GATEWAY OF THE PACIFIC 4 DENSITY TRANSFER PROJECT

Final Supplement Environmental Impact Report
SCH # 2008062059

Prepared for
City of South San Francisco

May 2022

Exhibit IV-17
CRITICAL AERONAUTICAL SURFACES
 — NORTHWEST SIDE
 Comprehensive Airport Land Use Plan
 for the Environs of San Francisco International Airport
 City/County Association of Governments
 of San Mateo County, California
C/CAG

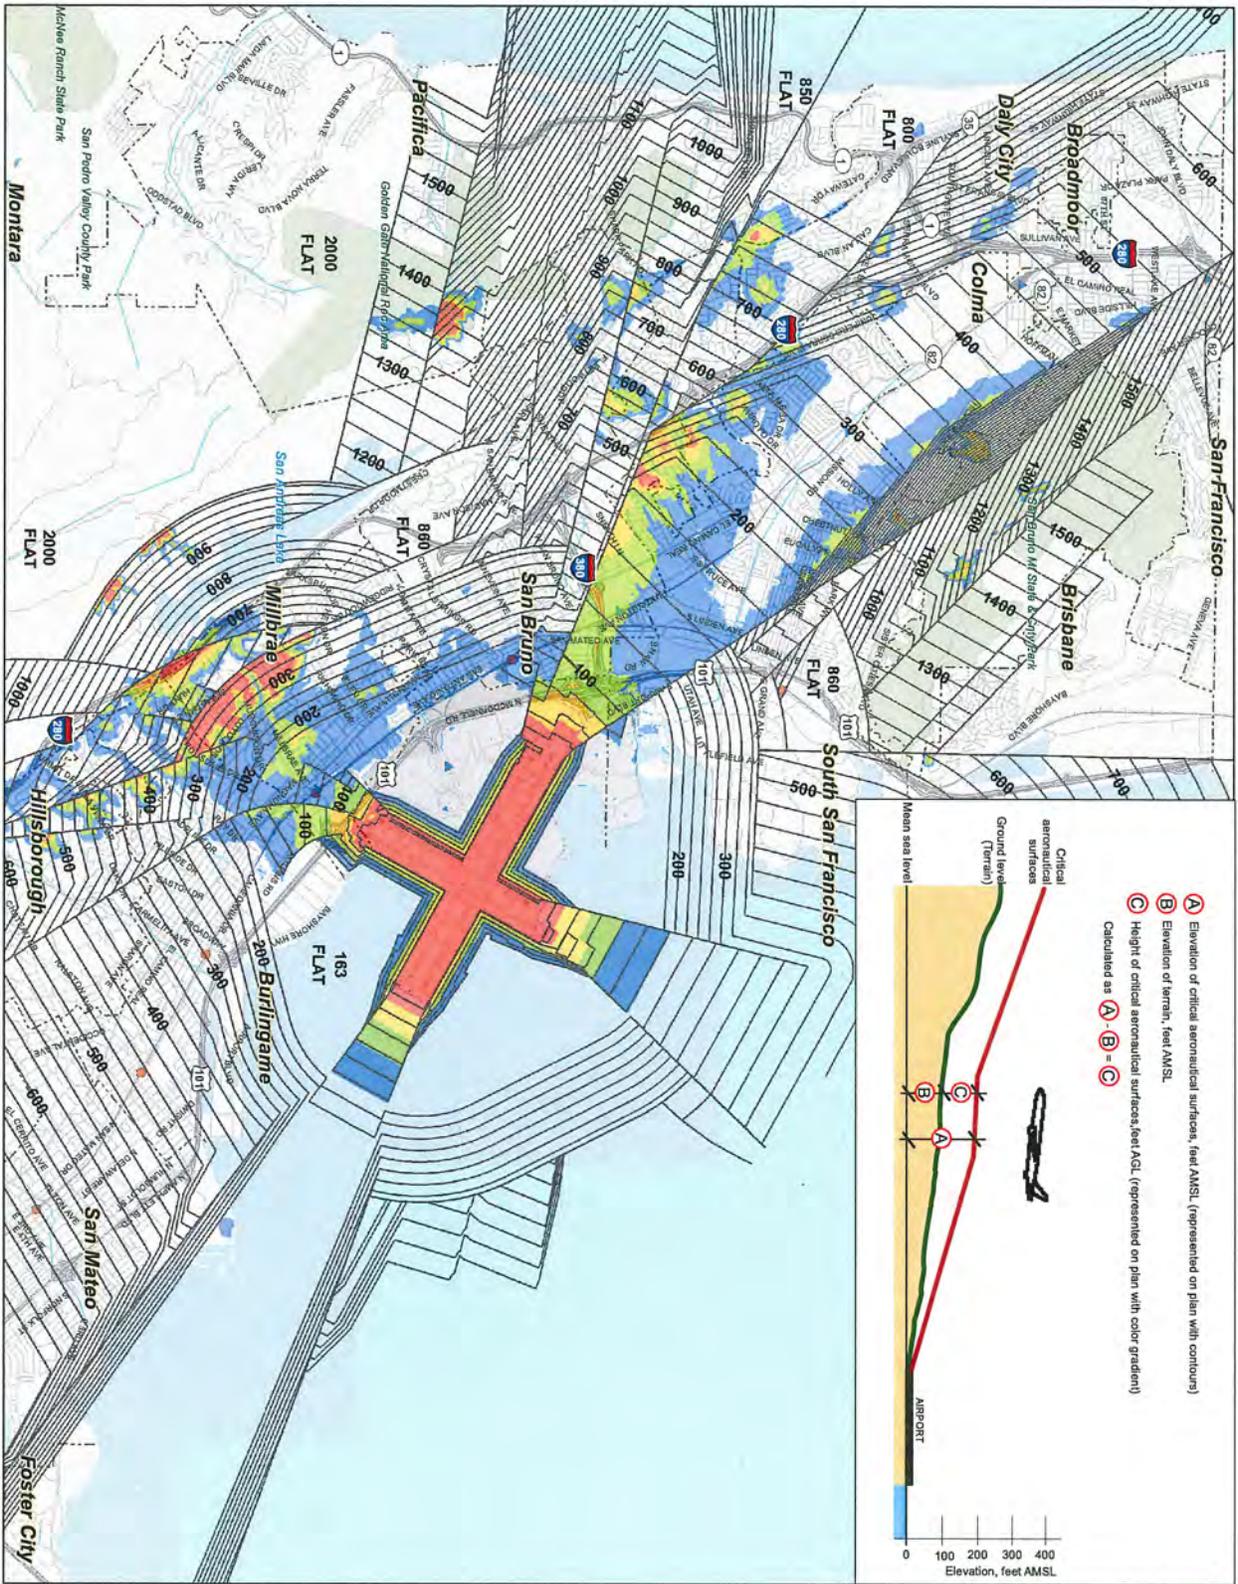
As described in Exhibit IV-17 of the SFO ALUCP (see Attachment), the critical aeronautical surfaces at the Proposed Project location would be at an elevation of between approximately 510 and 540 feet NAVD88. Thus, the estimated maximum elevation of the Proposed Project (201 feet NAVD88) would be below the

critical aeronautical surfaces and the Proposed Project would not appear to be incompatible with the Airspace Compatibility Policies of the SFO ALUCP, subject to the issuance of a Determination of No Hazard from the Federal Aviation Administration (see below) for any proposed structures and determinations from the City/County Association of Governments of San Mateo County as the designated Airport Land Use Commission.

- 2-3 The comment states that the proposed project does not appear to be incompatible with the Airspace Compatibility policies of the SFO ALUCP, subject to the issuance of a Determination of No Hazard from the Federal Aviation Administration (FAA) and determinations from the San Mateo County Airport Land Use Commission. The comment does not assert any inadequacies in the analysis included in the Draft SEIR. No further response is required.
